Project	IEEE 802.16 Broadband Wireless Acces	s Working Group http://ieee802.org/16 >			
Title	HO Latency Reduction				
Date Submitted	2008-05-14				
Source(s)	Brian Shim, Sungjin Lee, Geunhwi Lim, Samsung Electronics	Voice: +82-31-279-5248 E-mail: steve.lee@samsung.com			
	Xiangying Yang				
	Intel	E-mail: xiangying.yang@intel.com			
	Vladimir Yanover, Nadav Lavi				
	Alvarion	E-mail: vladimir.yanover@alvarion.com			
	Tzavidas Stavros				
	Motorola	E-mail: stavros.tzavidas@motorola.com			
	Kiseon Ryu				
	LGE	E-mail: ksryu@lge.com			
	Yerang Hur	, ,			
	Posdata	E-mail: yehur@posdata-usa.com			
Re:	LB26c				
Abstract	This proposal proposes a method to reduce	e handover latency.			
Purpose	Review and adopt.				
Notice	This document does not represent the agreed views of the IEEE 802.16 Working Group or any of its subgroups. It represents only the views of the participants listed in the "Source(s)" field above. It is offered as a basis for discussion. It is not binding on the contributor(s), who reserve(s) the right to add, amend or withdraw material contained herein.

Handover Latency Reduction

Figure A - Seamless HO call flow

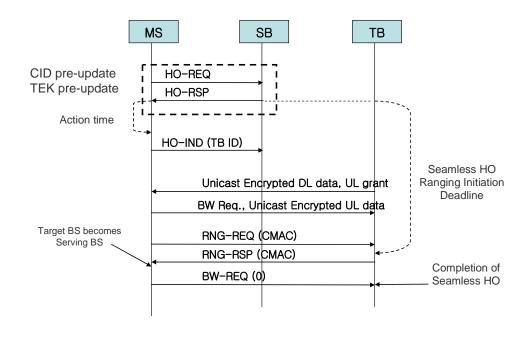
<u>During seamless HO</u>, the target BS (T-BS) may allocate downlink and uplink resource for the MS before the RNG-REQ/RSP message transaction, as shown in figure A.

The RNG-REQ/RSP transaction for Seamless HO is shown in Figure A. MS shall initiate RNG-REQ/RSP transaction by transmitting RNG-REQ message to target BS before the deadline specified by the "Seamless HO Ranging Initiation Deadline" attribute included in BSHO-REQ/RSP message during handover preparation. The RNG-REQ message shall include Basic CID, CMAC KEY COUNT and valid HMAC/CMAC tuple. Ranging Purpose Indication TLV with Bit #2 set to 1, but not include MS MAC address—or previous serving BS-ID. When BS receives the RNG-REQ message, BS shall respond to the RNG-REQ message by transmitting RNG-RSP message with valid HMAC/CMAC tuple. The RNG-RSP message does not need to include any CID update TLV or SA-TEK-Update TLV.

When MS receives the RNG-RSP message from the target BS, the target BS becomes serving BS of the MS and MS shall transmit a BR header with 0 bandwidth request. When BS receives the BR header, the Seamless HO procedure completes successfully.
